Site Accessibility Evaluation

**Path of Travel Bus Stop
Accessibility
PU18-000091**

**Galley Road / Peterson
Road
Cimarron Hills, CO 80915**

Finding: 1

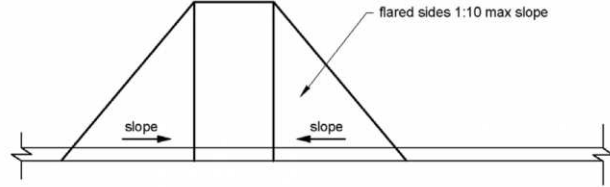
No diagonal or corner curb ramp exists.

Citation:

2010 ADAS Section: 406.3

As Built:

Curb ramps non
existent

Recommendation:

Design and construct curb ramp for accessible path of travel. See 2010 ADAS section 4.06 for specifications and compliance. Maximum running slope of 1:12 (8.33%) and maximum cross slope of 1:48 (2.08%). if provided, curb ramp flares shall not be steeper than 1:10 (10%)

Corrective Action: Department of Public Works submitted and completed 2 compliant curb ramps along with 215 linear feet of 6 feet wide detachable sidewalk on 8/31/2018
